**RE: Curia Building Addition
34401 Alexander Blvd. NE Albuquerque, NM 87107
Grading and Drainage Plan (F16D003B1)
Engineers Stamp Date 10/25/2022**

Re: Curia Building Addition
4401 Alexander Blvd NE Albuquerque, NM 87107
Grading and Drainage Plan (F16D003B1)
Letter of Response

RE: **Oso Bio Syringe Line**
4401 Alexander Blvd NE
Grading and Drainage Plan for Building Permit
Engineer's Stamp Date 11/1/2018 Disapproved
Hydrology File: F16D003B1

Re: Oso Bio Syringe Line Grading Plan Submittal; Hydrology File F16D003B1

OSO BIO SYRINGE LINE DEMOLITION PLAN			
DRAWN BY:		DATE:	
CHECKED BY:		PROJECT NO. 20190058	SHEET NO. C1.0

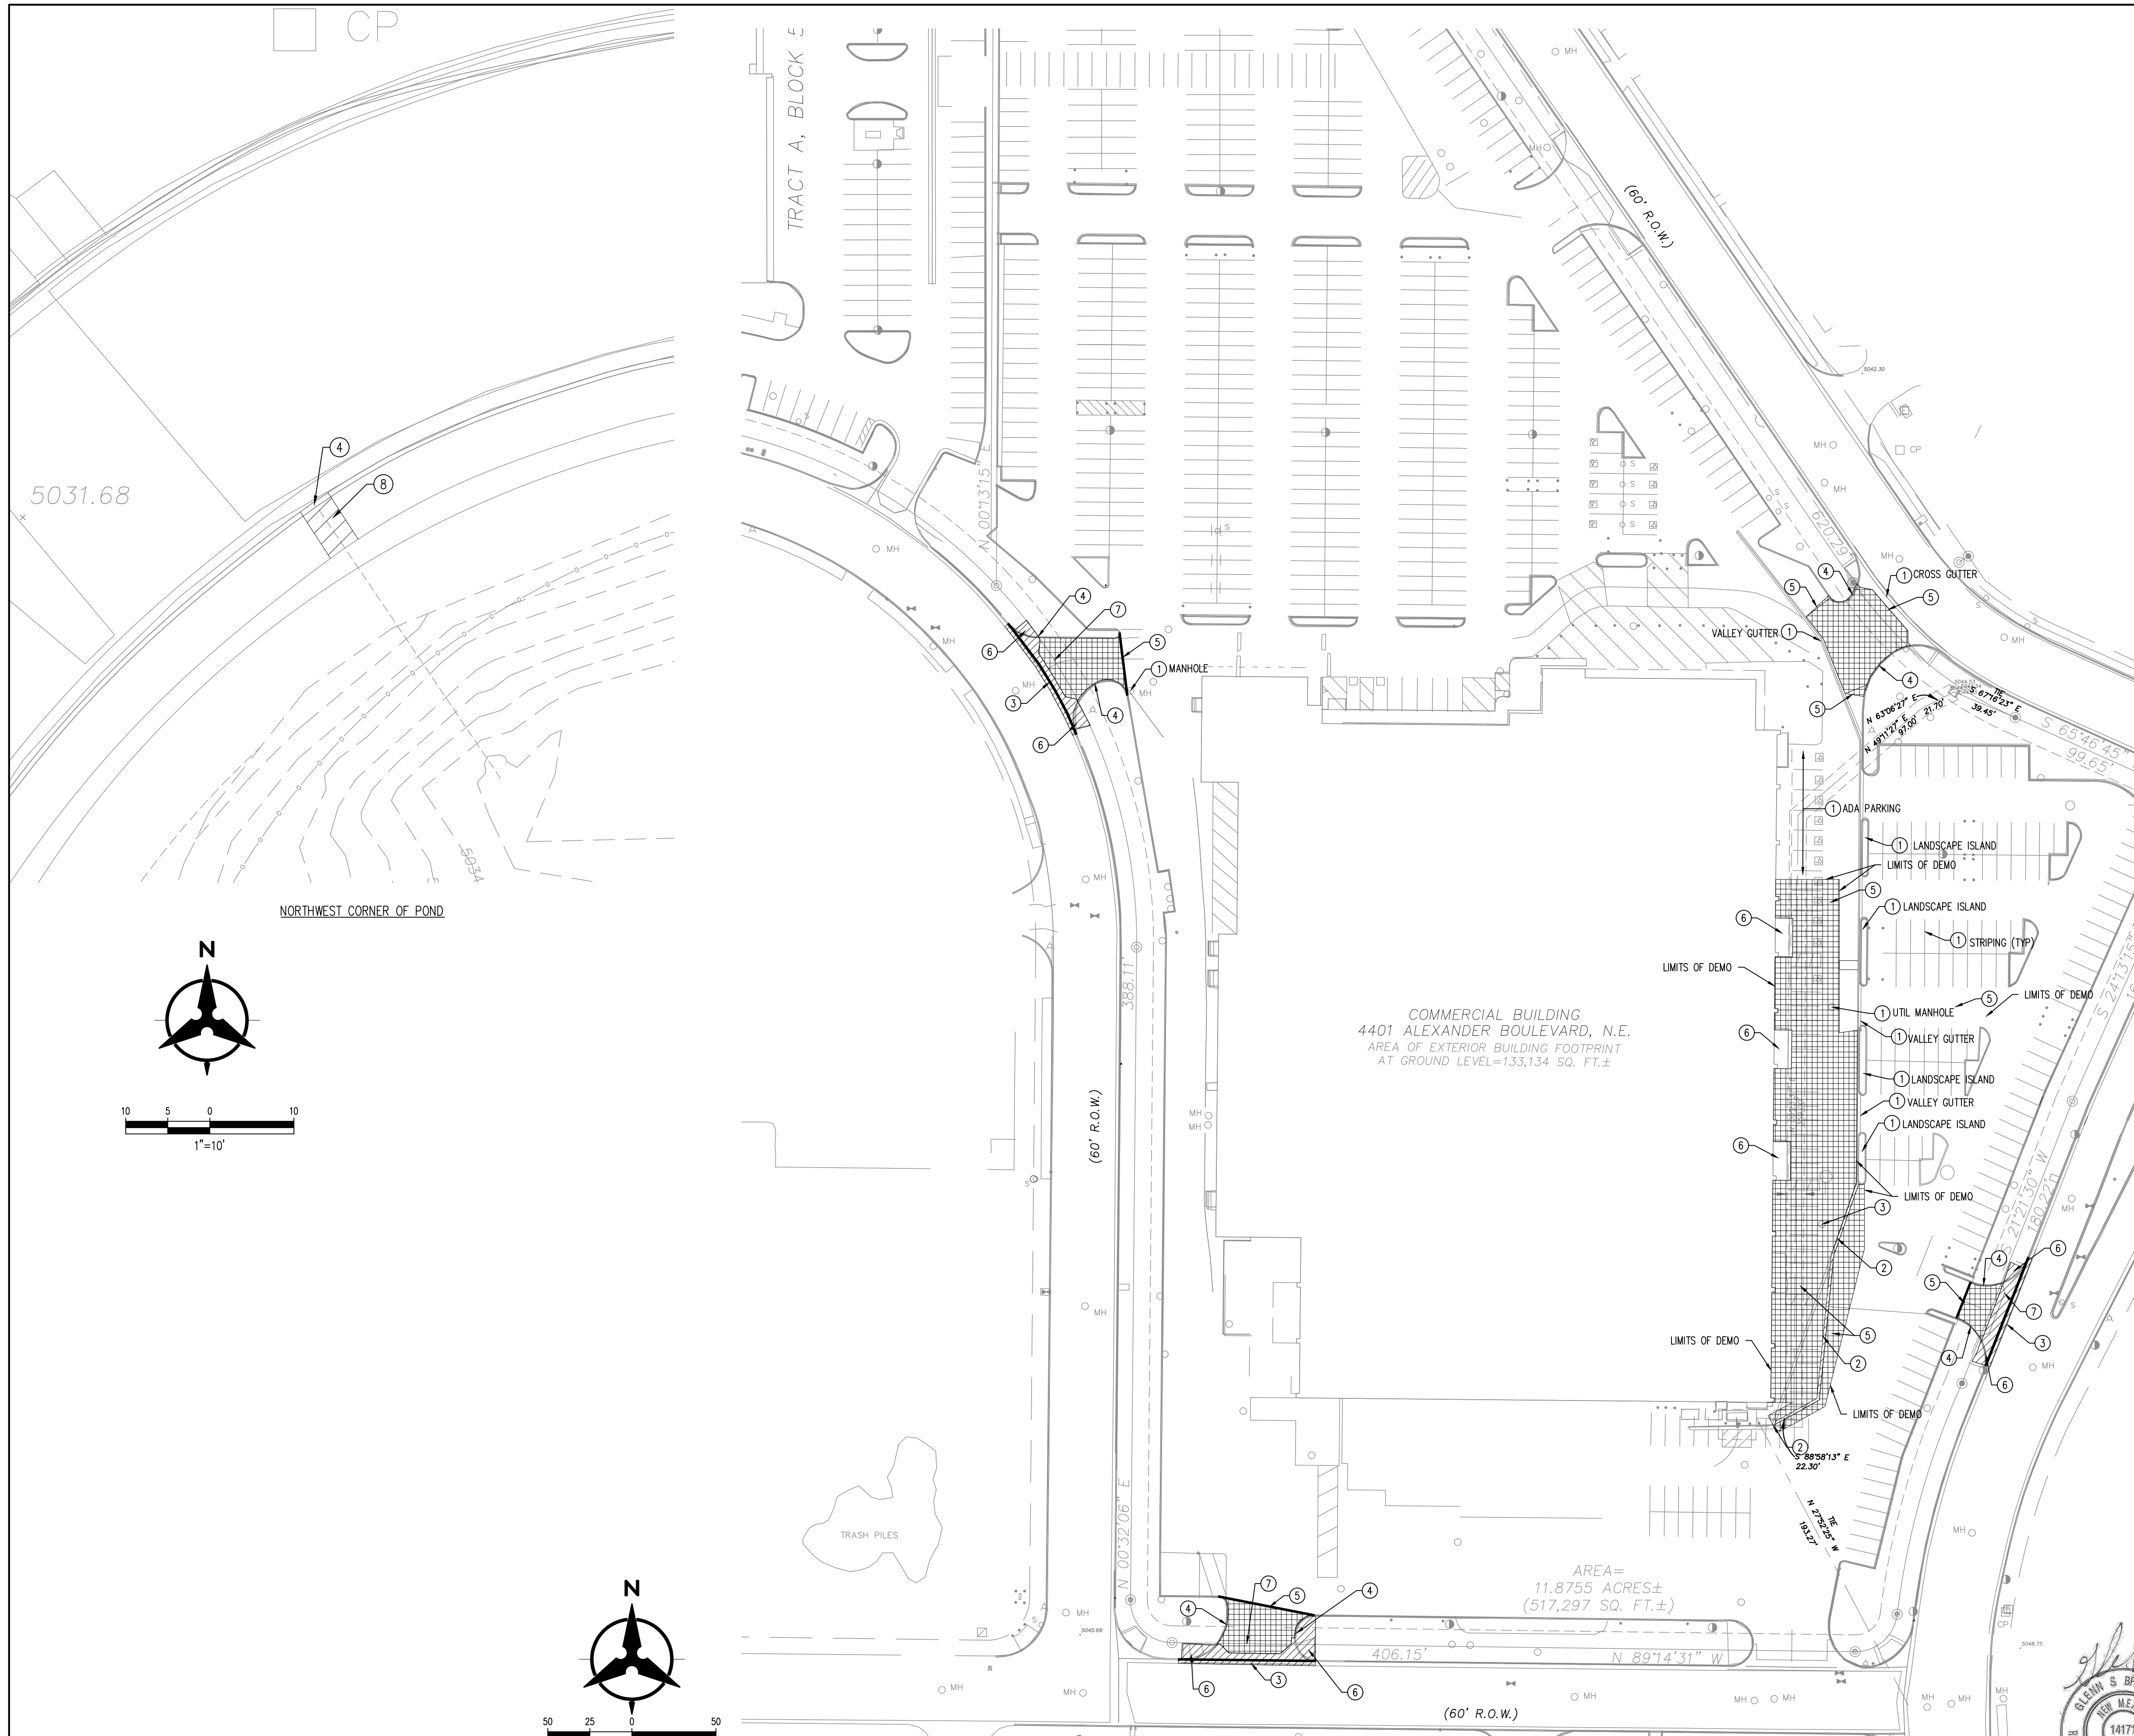
1. A digital submittal include HEC-HMS models have been provided with this submittal.
2. SO-19 notes have been deleted from sheet C1.0 and added to sheets C1.1, C1.3 and C1.4. The standard drawing for sidewalk culverts have been added to the keyed notes.
